ERRATA LIST

Apollo3 Blue Plus SoC

Doc. ID: SE-A3P-5p3

Doc. Revision: 5.3, September 2022

Figure 1. STIMER Compare Register Update Race Condition

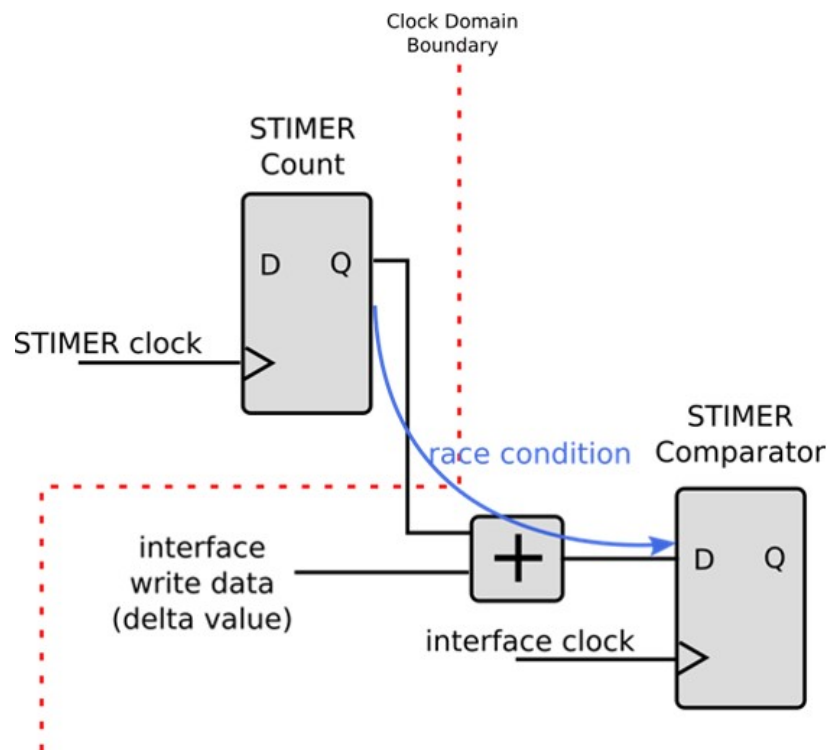
The STIMER compare register may capture invalid data as the add operation is in the process of computing the new value. Thus there is a race condition between the STIMER clock and the interface clock.

Mistimed STIMER interrupts could occur as a result of invalid compare values being written to the compare register.

A workaround is to create a critical section in code to set the STIMER compare value without the possibility that invalid data will get captured for the STIMER clock value. The general program flow for the critical section would be as follows:
